## **IMPORTANT SAFETY RECALL**

### **NHTSA Recall Campaign # 16V555**

## Service Bulletin

### 503067 Rev. A

**Correct**

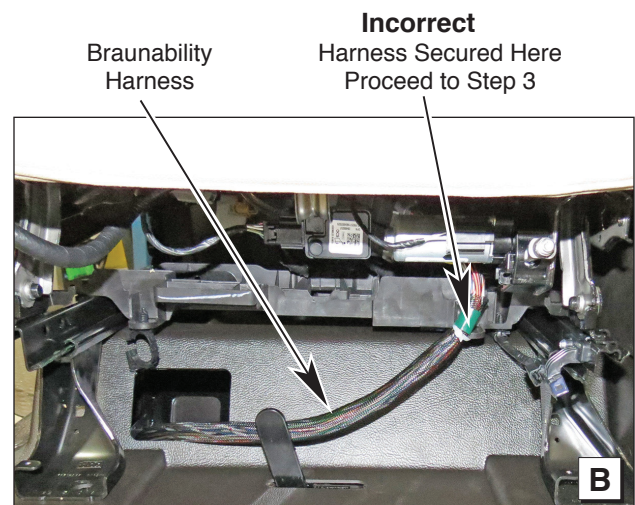
Harness must be secured at location shown in Photo A.

If harness is secured at location shown in Photo A, no further action is required.

Harness Secured Here  
No Further Action Required

**Incorrect**

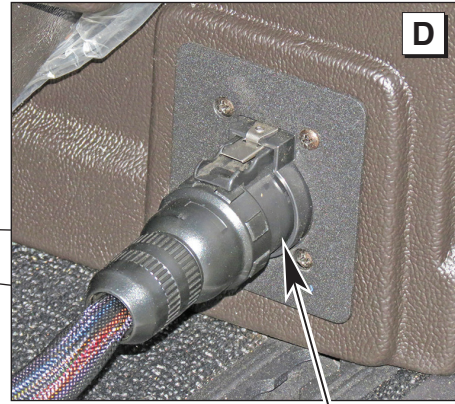
If seat harness is secured at location shown in Photo B, proceed to Step 3.

Harness Secured Here  
Proceed to Step 3

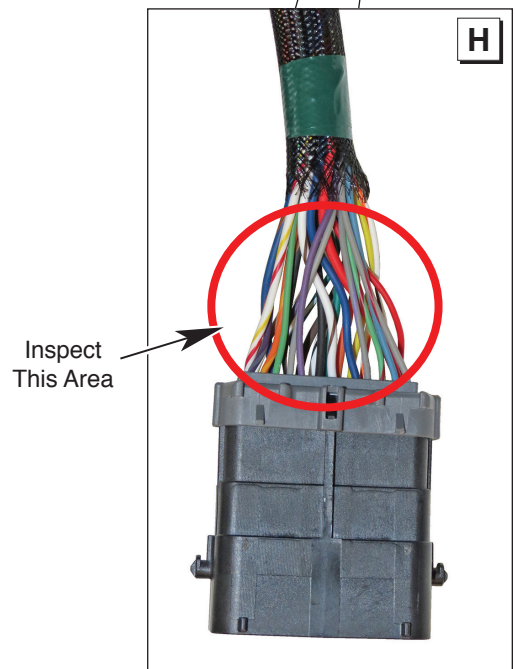
8. At 34 pin connector, inspect harness 501964A for damage. See Photo H.

If any wires are damaged, harness 501964A must be replaced with 16V555KS.

Note: If damaged, discontinue use of seat until harness is replaced.

Harness Routing on Top of Cross Member

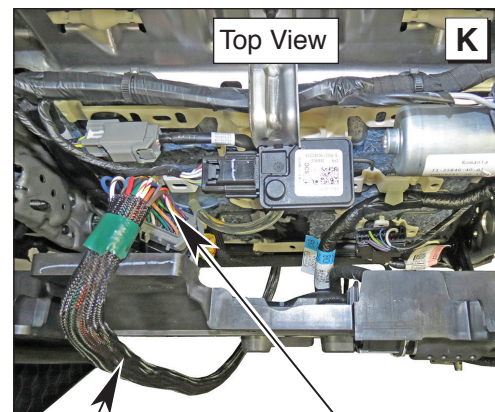
10. Route OEM seat harness on top side of seat cross member as shown in Photo J.

Harness 501964A 34 Pin Connector

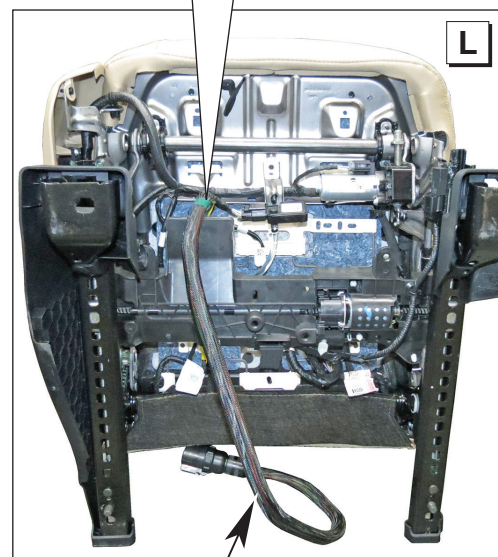
11. Connect 34 pin connector of harness 501964A to 34 pin connector on OEM seat harness at location shown. See Photos K and L.

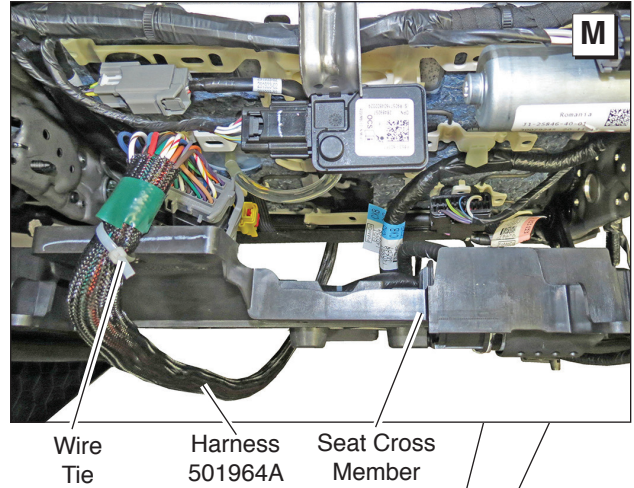
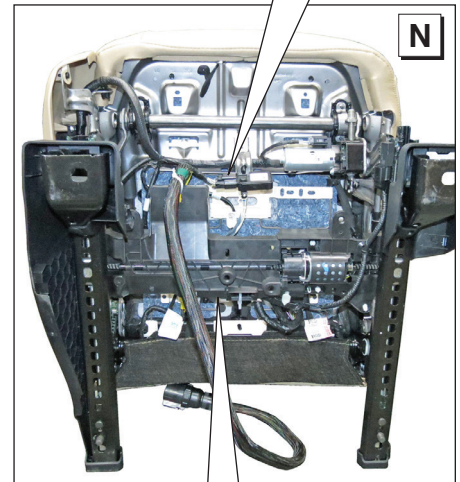
- Secure harness 501964A to seat cross member with wire tie as shown in Photo M.

- Secure OEM seat harness to seat cross member with wire ties (2). Ensure proper routing on top of seat cross member. Refer to Photos J, N, and O.
